Amendments to the Drawings:

REMARKS/ARGUMENTS

Appl. No: 10/636,020
Reply to Office Action of June 15, 2005
Annotated sheet showing changes

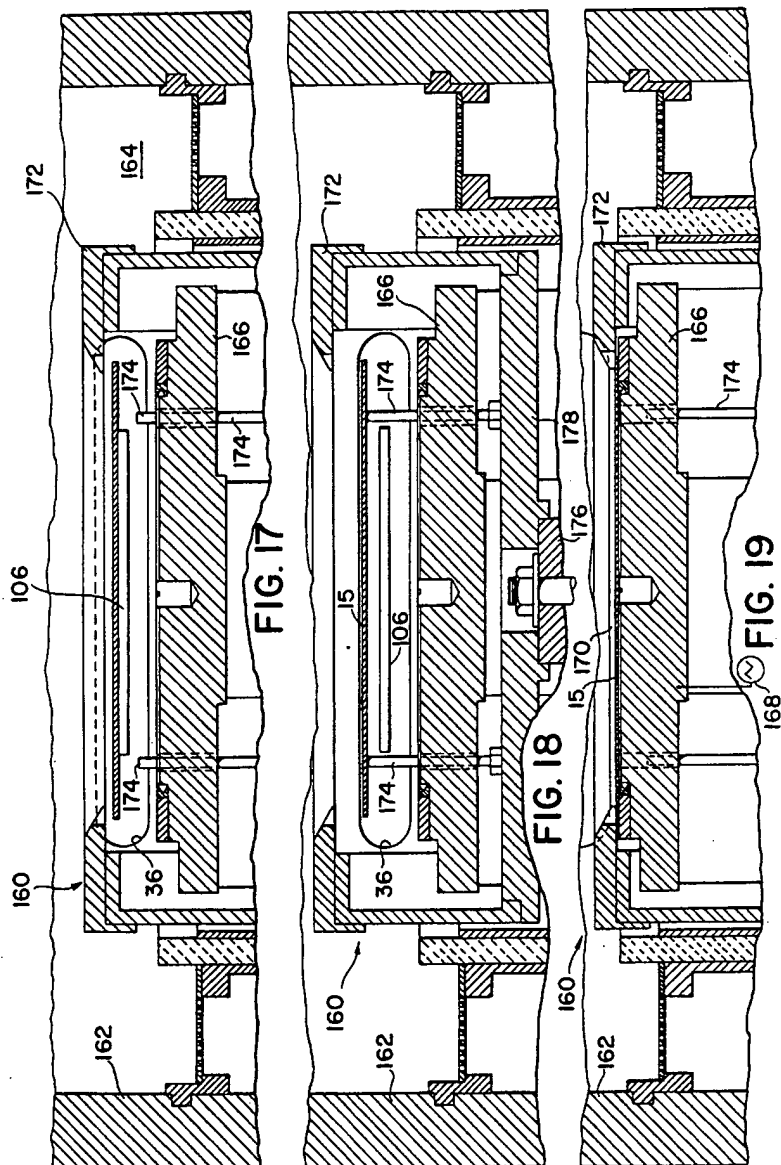
Cheng is also silent regarding the process chamber opening, but one can infer the dimension of the process opening by Maydan et al. (U.S. patent 4,951,601), which is made a cross-reference by Cheng. In Maydan, Fig. 16-19, sheet 6 of 7 (see figure attached), the process chamber opening 36 is only slightly larger than the workpiece 15, therefore could not accommodate the shield 3 to 4 times larger in diameter than the workpiece. Using this information, together with Cheng's silence on the subject, the Applicant submits that no one skilled in the art could anticipate or render obvious that Cheng's shield can be replaced in the same way as the replacement of the workpiece.

Cheng is also silent regarding the way the workpiece and the shield can be replaced. Using the same information from Maydan (Fig. 16-19, sheet 6 of 7), the workpiece 15 is shown

Fig. 2 (Prior Art)

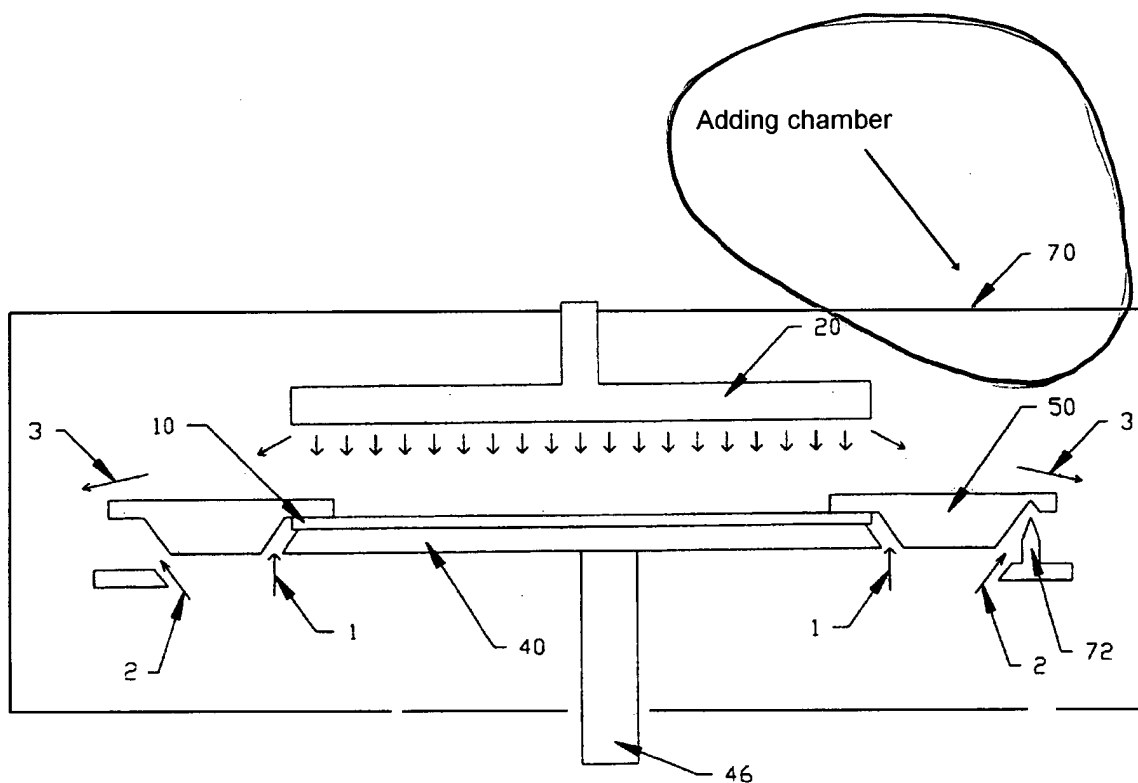
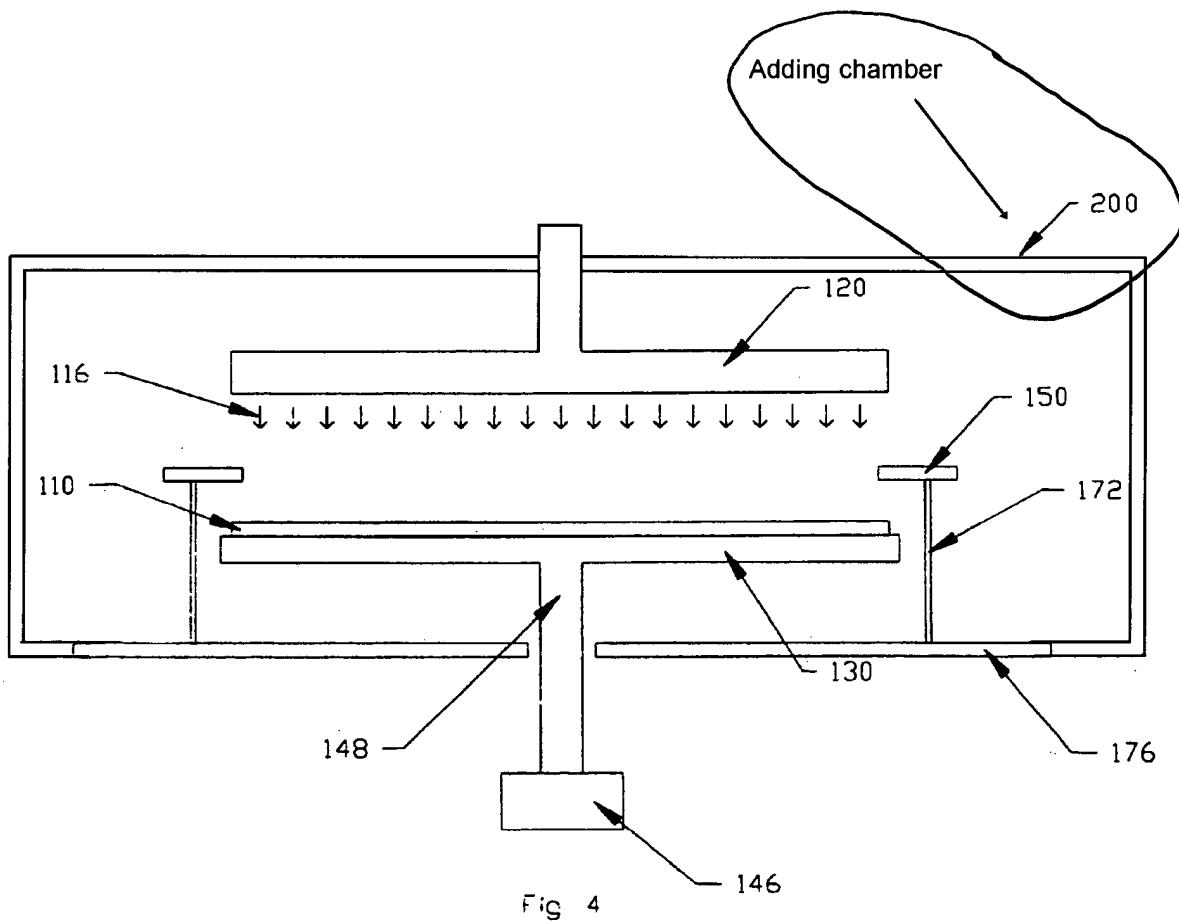
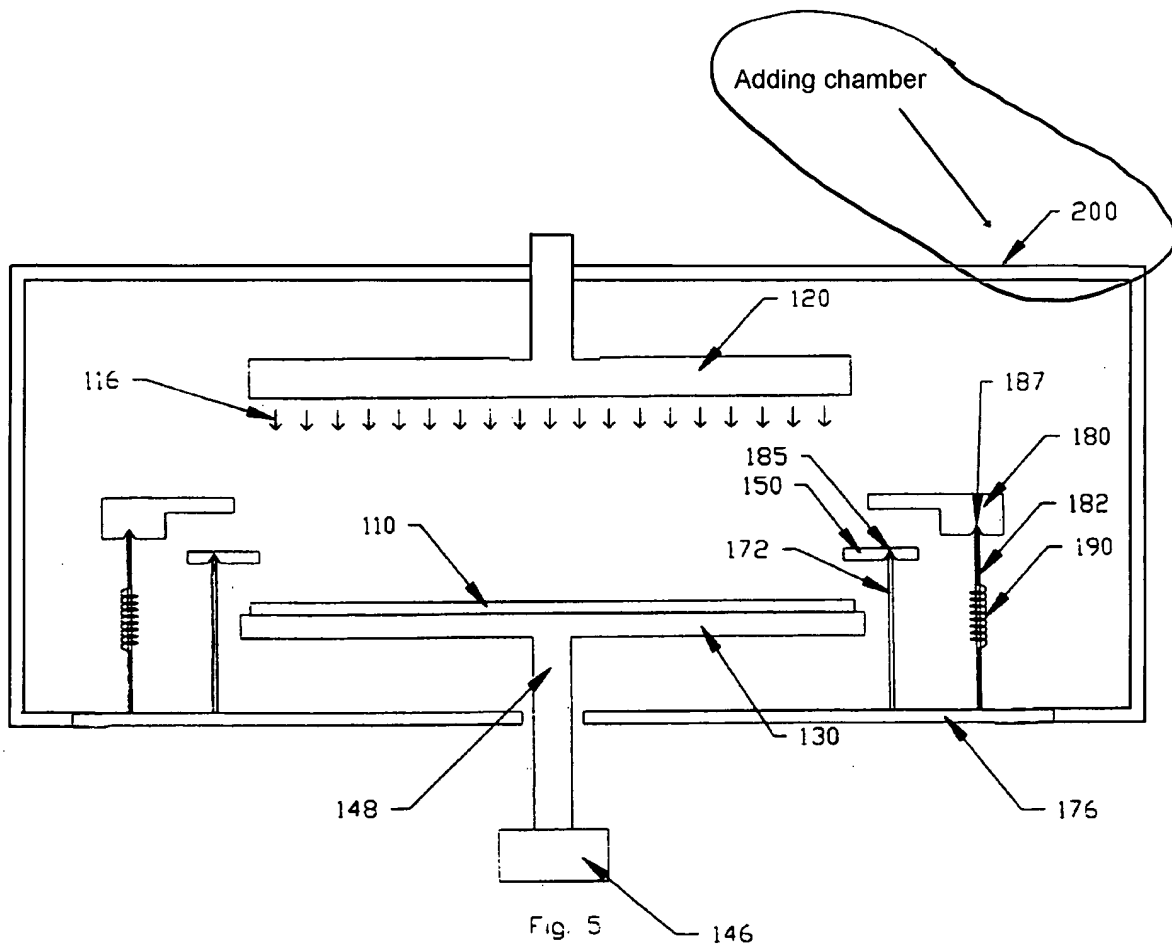
In Fig. 2, the drawing of a chamber 70 has been added. In Figs. 4-6, the drawing of a chamber 200 has been added.

(1) With regard to the objection of the drawings under 37 CFR 1.83(a), Applicant has amended the drawing to overcome the Examiner's objection. Specifically, Applicant has added a chamber drawing 70 and 200 to Fig. 2 and Figs. 4-6, respectively.

The support for the chamber 70 in Fig. 2 is from the paragraph [0006] (as numbered in U.S. Patent Publication No. US 2002/0179014), discussing the drawback of the prior art of Fig. 2, that the chamber 70 needs to be vented before shield replacement, and then chamber 70 needs to be pumped down and conditioned for process qualification. Paragraph [0006] also has been amended to add the reference sign 70 to the chamber of Fig. 2.

Fig. 6

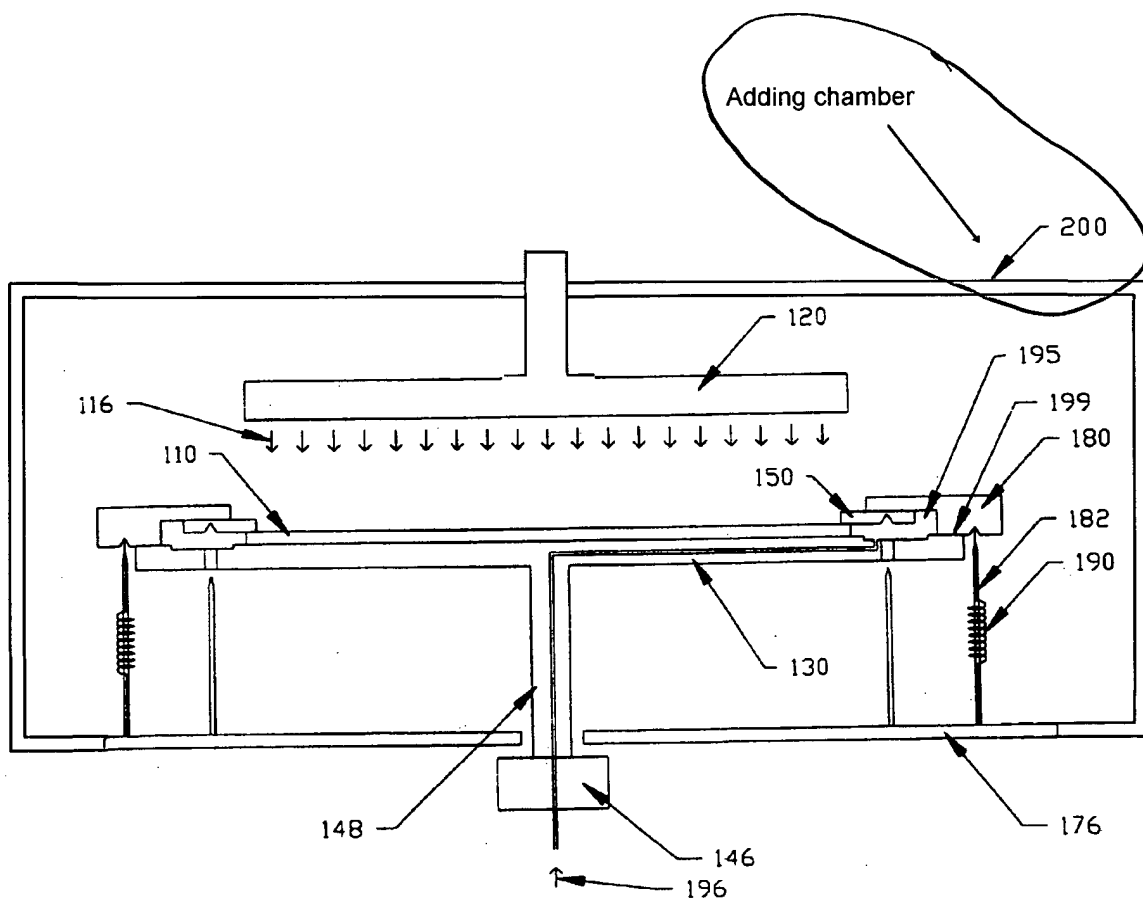
The support for the chamber 200 in Fig. 6 is from the paragraph [0042] (as numbered in U.S. Patent Publication No. US 2002/0179014), discussing the pressure difference between the cavity and the chamber pressure. “*The cavity 195 retains the purging gas, created a higher pressure in the cavity 195 than in the chamber.*”. Paragraph [0042] has been amended to replace “the chamber” with “the chamber 200”, showing the reference sign 200 to the chamber of Fig. 6.
